Lead Local Flood Authority

RE: DISC/26/0085 - Land At 509354 126590 Hilland Road Billingshurst West Sussex RH14 9HN

This is an application for Approval of details reserved by condition 5 to approved application DC/25/0458 (surface water drainage).

From DISC/26/0085

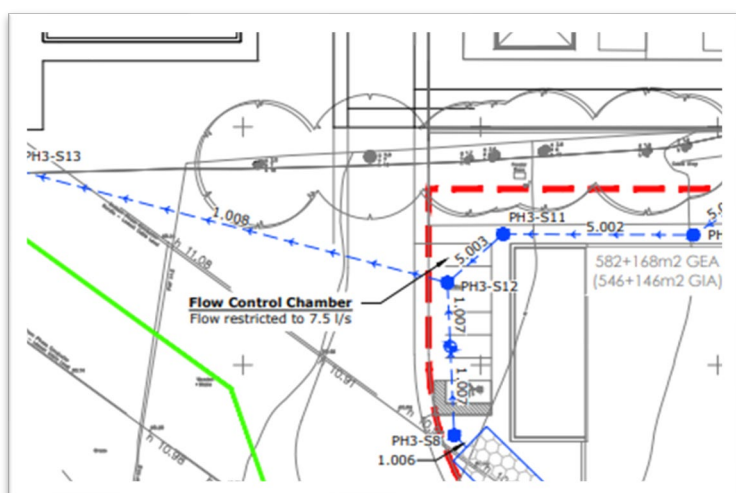
It is essential that drawings correspond with each other across the site. It is noted that the proposed connection for future development surface water sewer is proposed to be routed through existing trees in this drawing, while the outline application for that area shows the proposed connection for future development to be routed where the basins are being constructed under this application.
